# TERRA RIDGE NORTH CIVIL CONSTRUCTION PLANS El Paso County, Colorado

INDEX OF SHEETS	
SHEET NUMBER	SHEET DESCRIPTION
C1	COVER
C2	NOTES
C3	GENERAL NOTES AND ROADWAY SECTIONS
C4	ROADWAY KEY MAP SHEET
C5	PLAN AND PROFILE
C6	STORM PLAN AND PROFILE
C7	DETENTION POND STRUCTURE AND EMERGENCY OVERFLOW SECTION

EL PASO COUNTY DEVELOPMENT  
REPLAT TERRA RIDGE LOTS 5 & 6 W/ 11 LOTS IN  
TERRA RIDGE NORTH  
COVER SHEET

RURAL LOCAL – PAVED  
TYPICAL SECTION  
SCALE N.T.S.

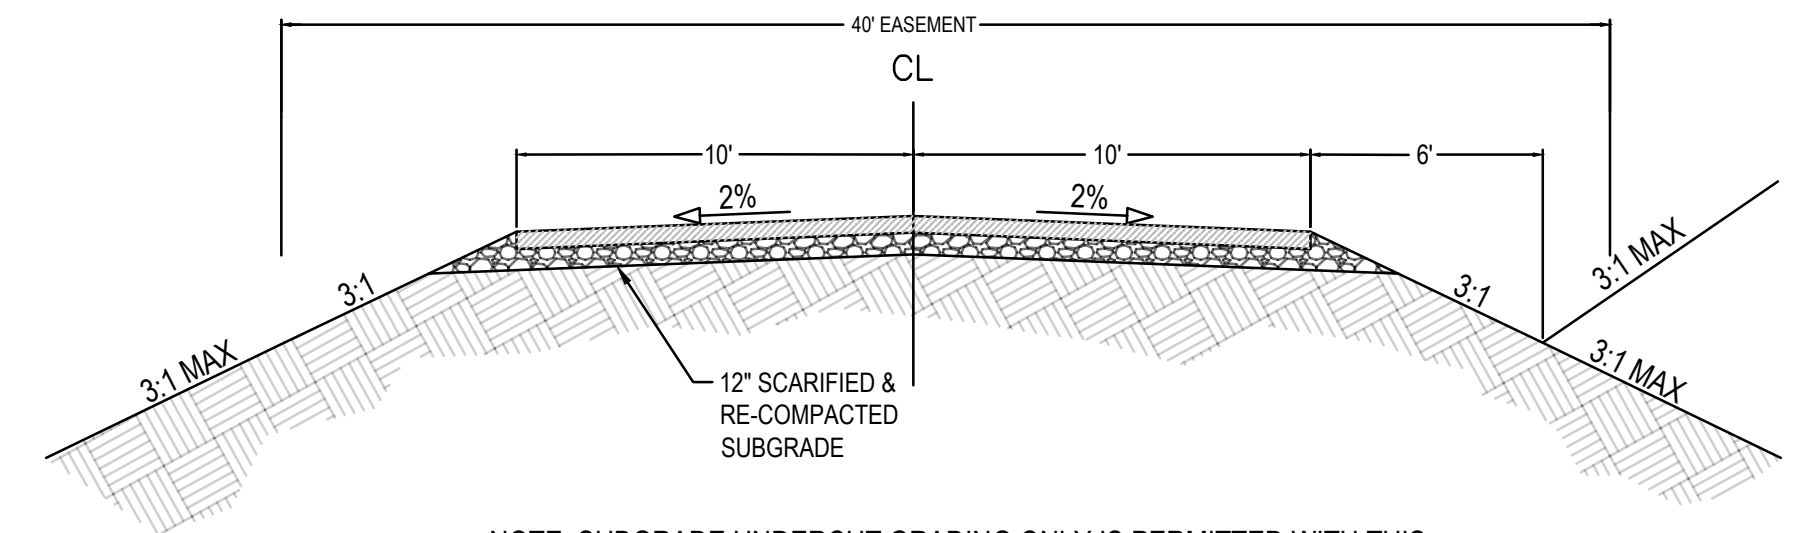
Update to 10' or revise the plat to 10' for consistency

Delete note

List proposed speed limit for road.

PRIVATE DRIVEWAY – PAVED  
TYPICAL SECTION  
SCALE: NTS

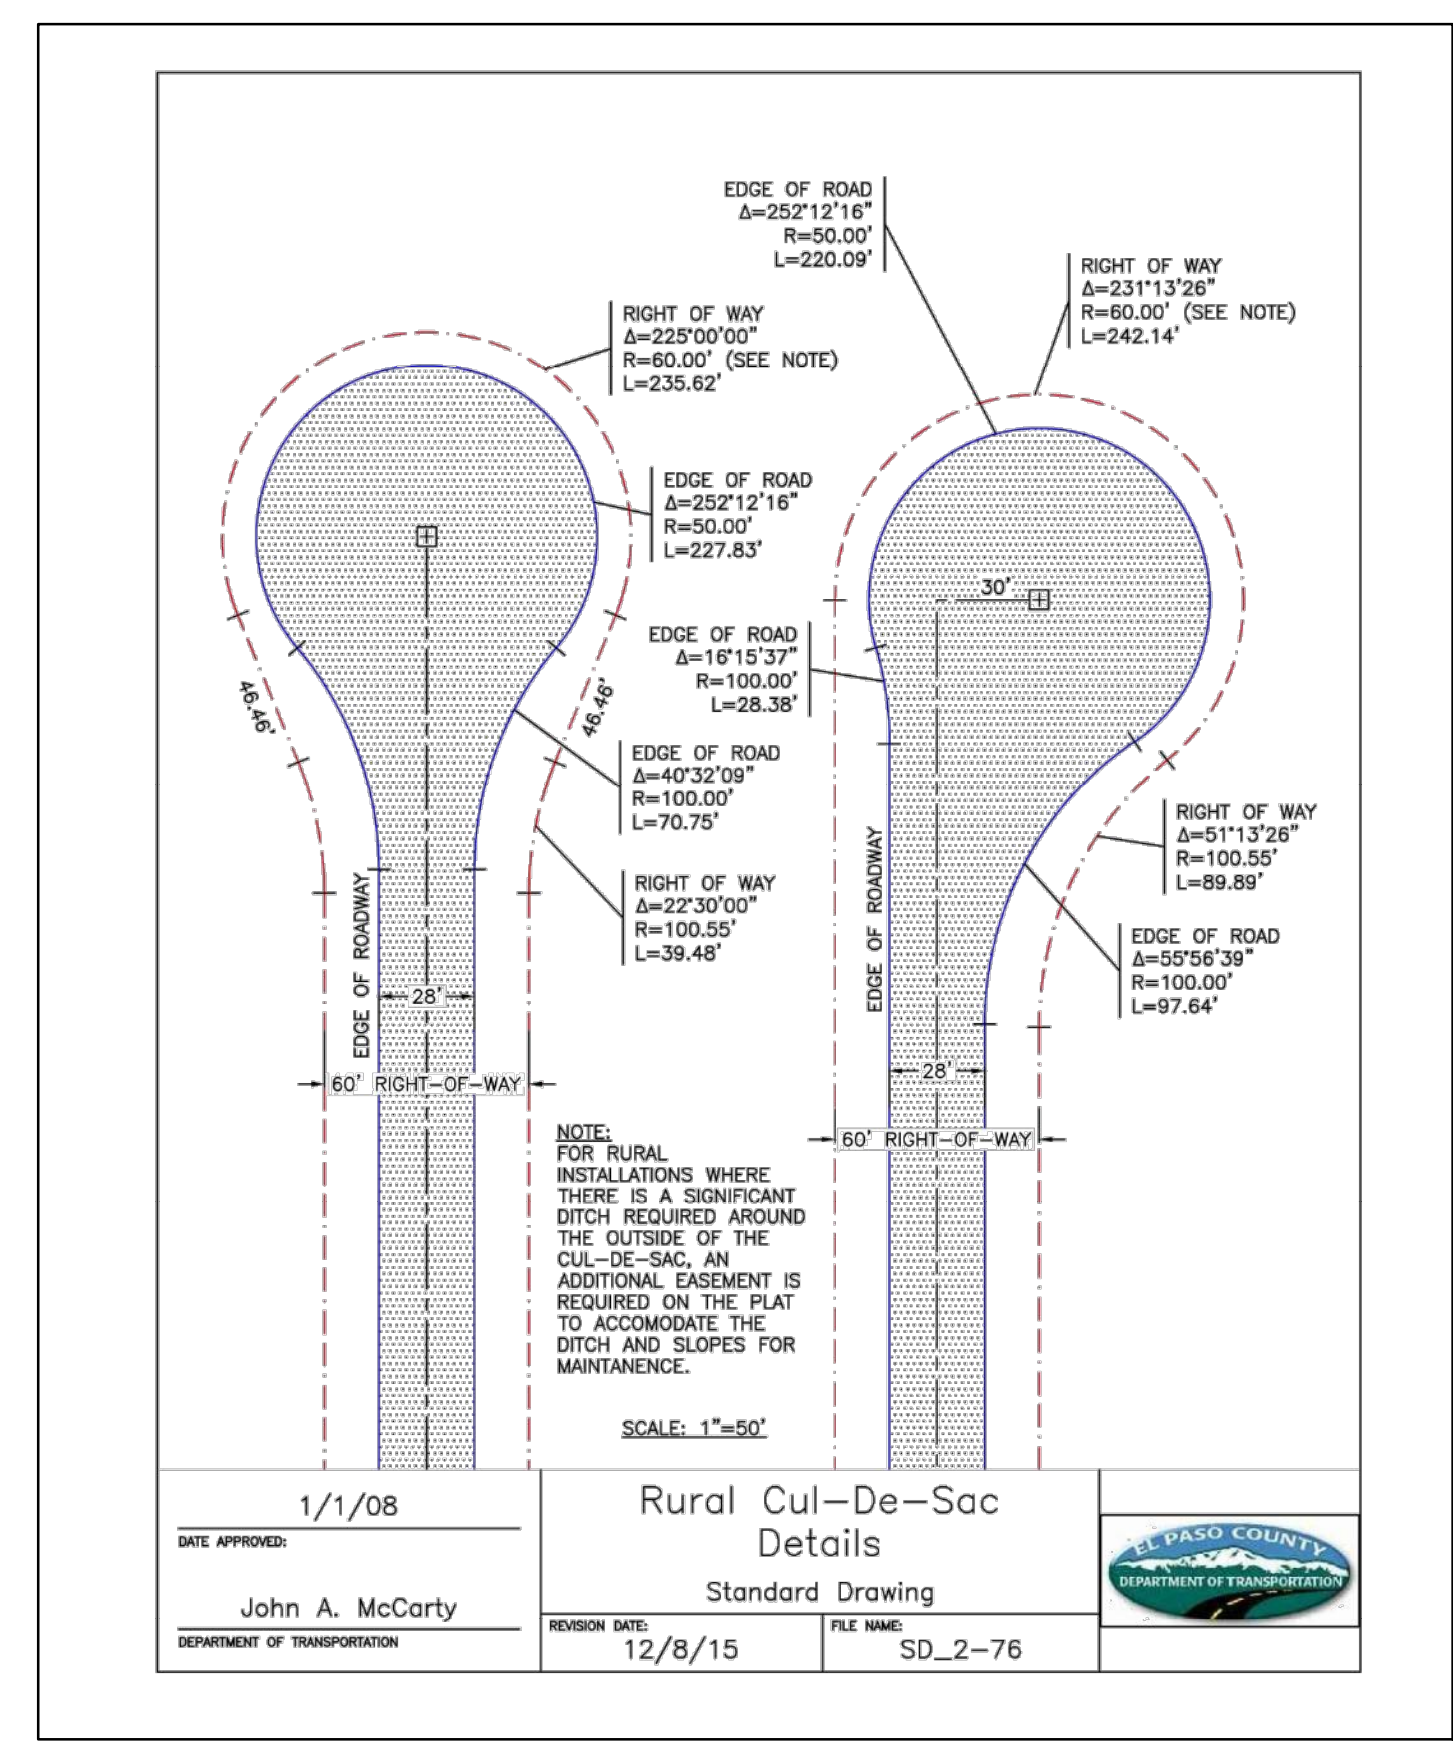
Delete note

FOX CREEK LANE STATION 0+00 TO 8+00

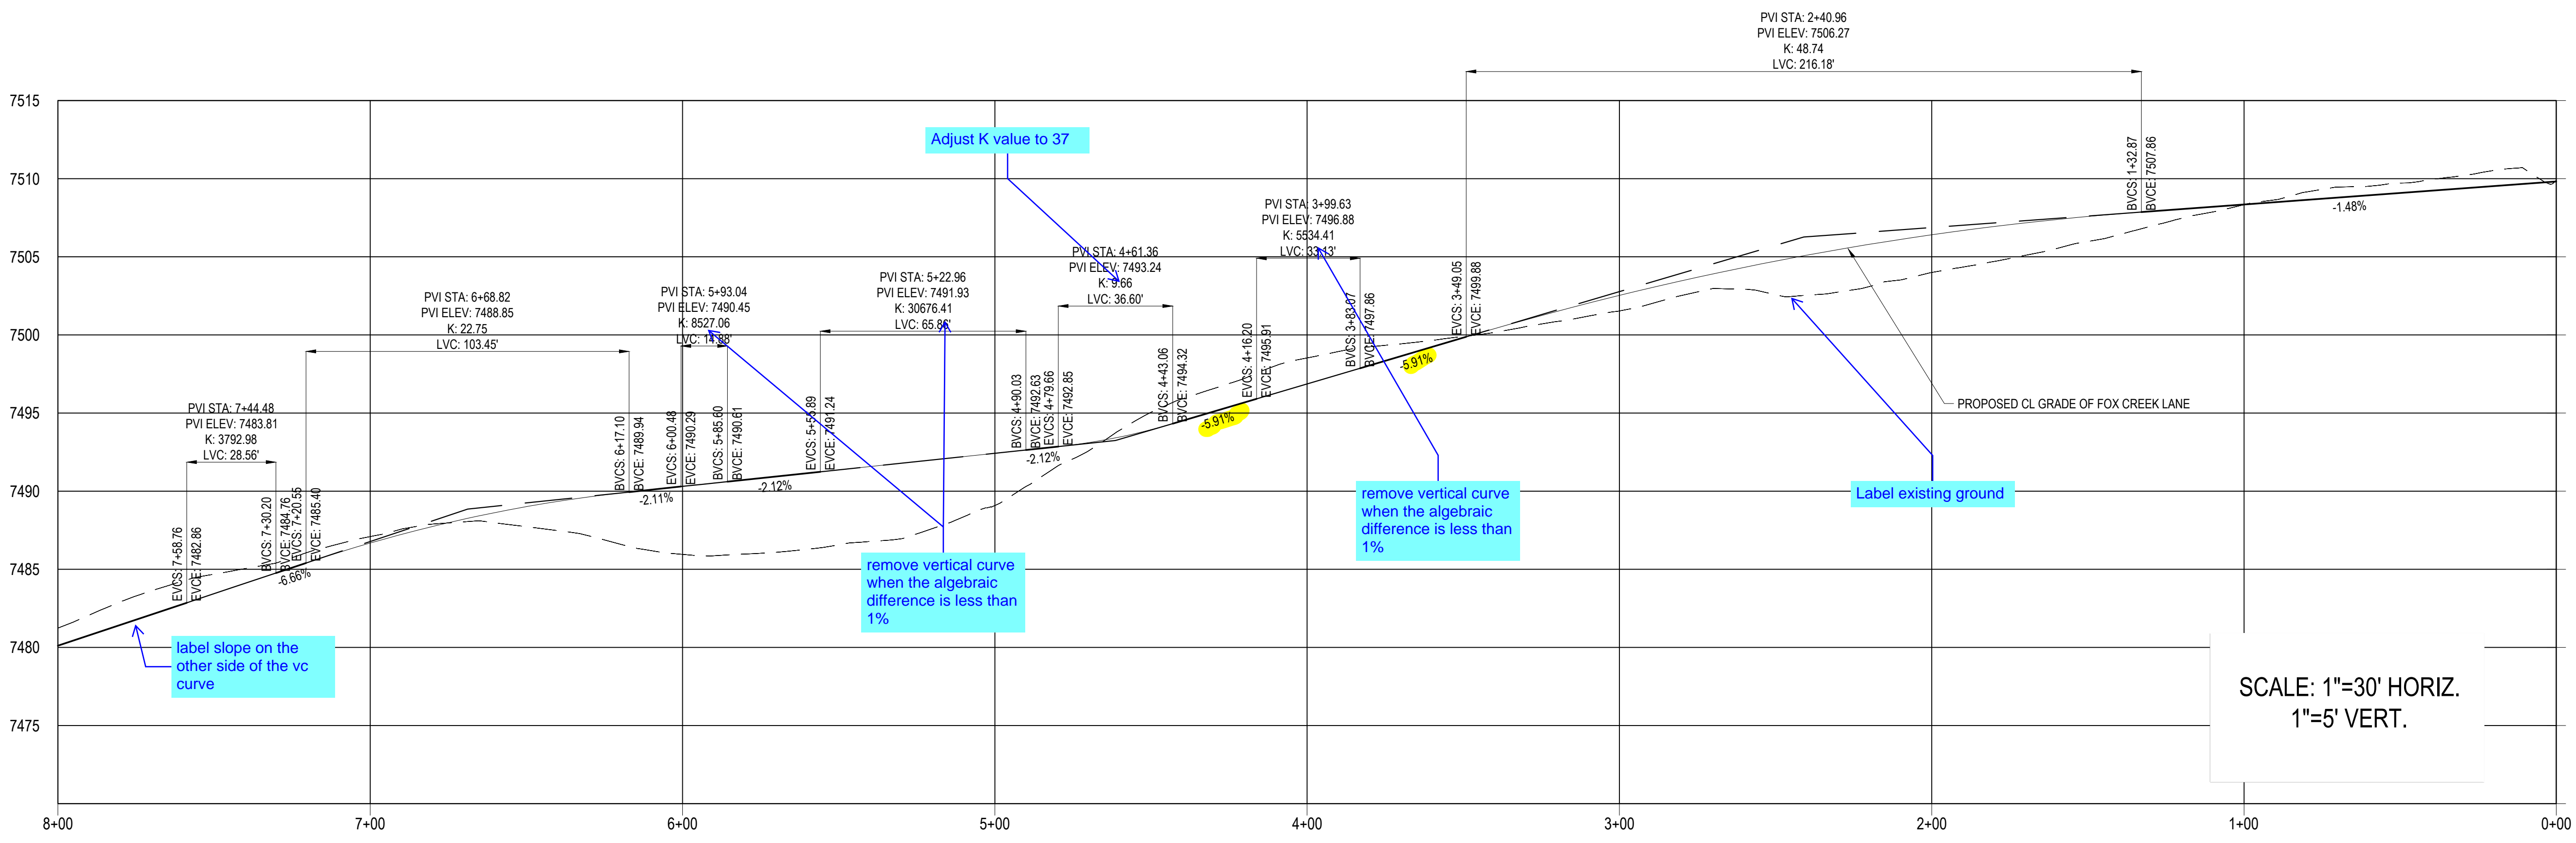
Per ECM table 2-5 minimum curve radius for a rural local road is 300'. Revise to meet criteria.

C-8 OUTLET STRUCTURE DETAILS  
NTS

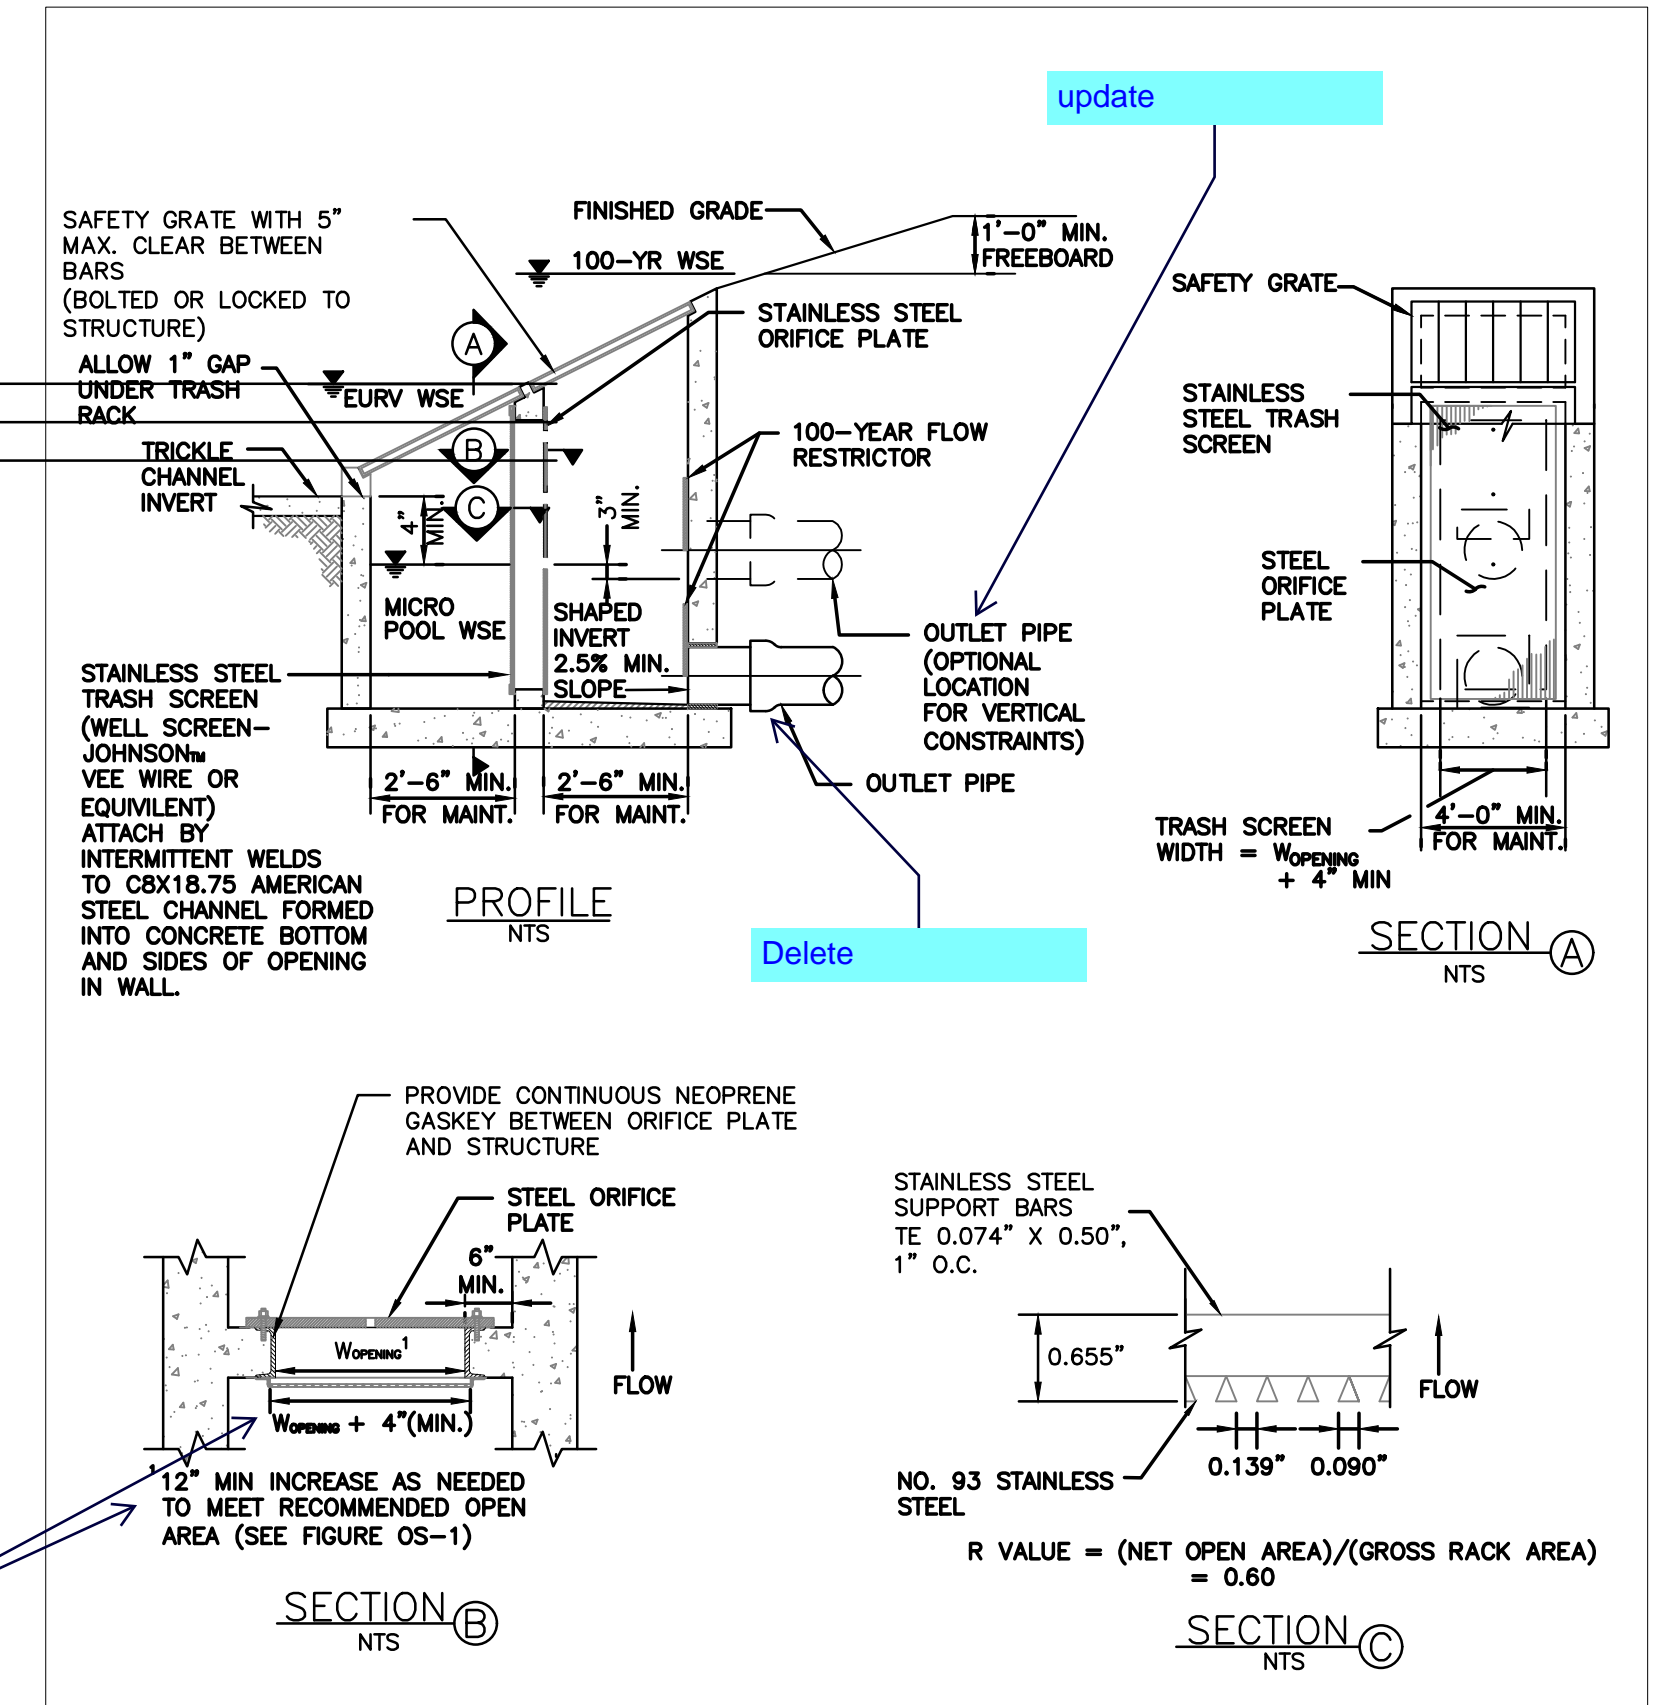
Provide orifice plate detail showing dimension and orifice dimension and elevation.  
provide elevations  
Provide restrictor plate detail.

C-7 SPILLWAY DETAIL  
NTS

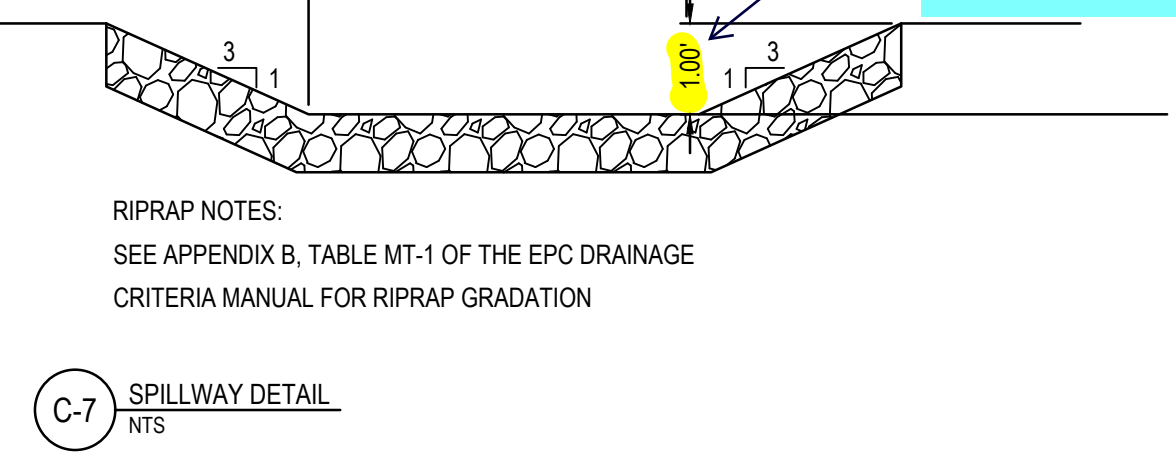
adjust. per MHFD-Detention calculation the height needs to be 1.60 ft in order to provide a 1' freeboard above the overflow depth.

C-6 OUTLET STRUCTURE  
SCALE 1"=2'

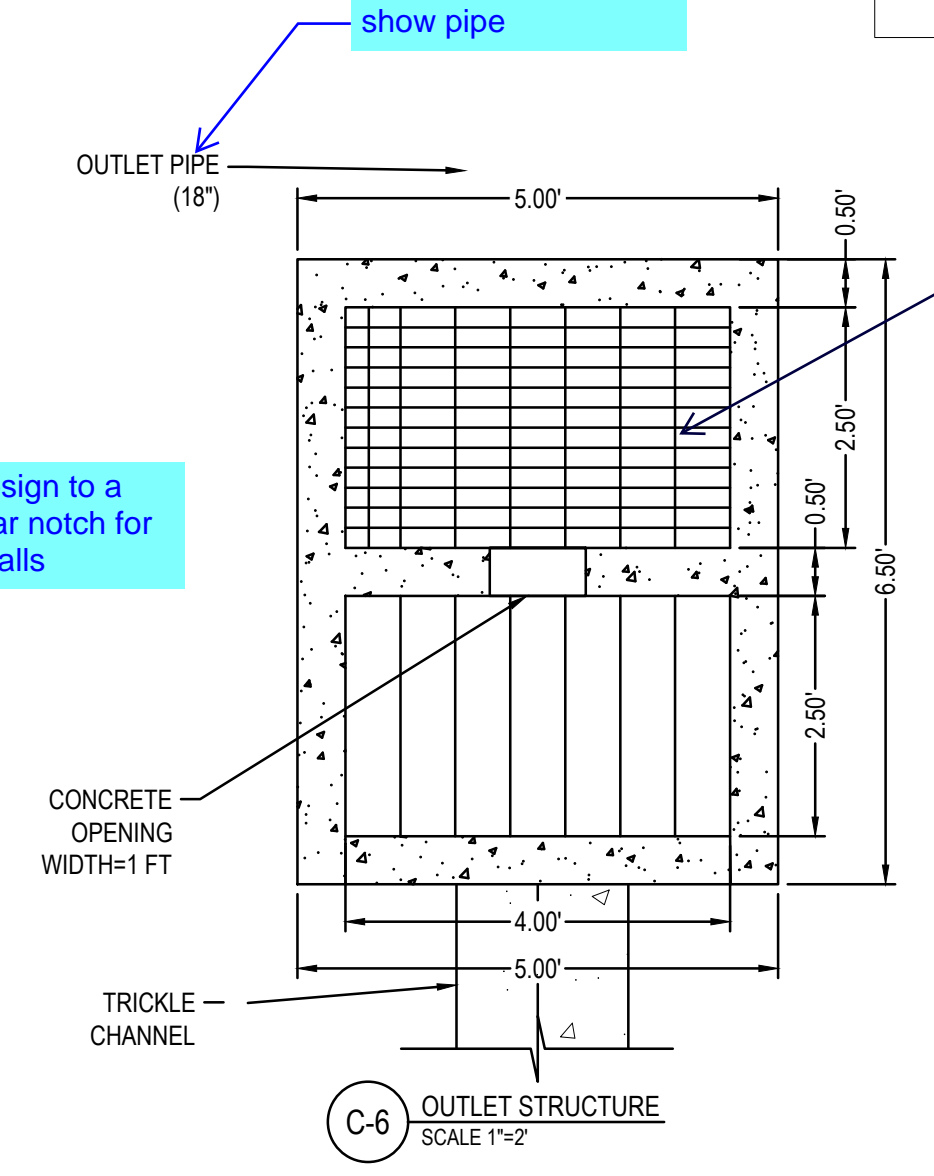
provide information for the grate to be installed on the second chamber

show the finished grade relative to the structure
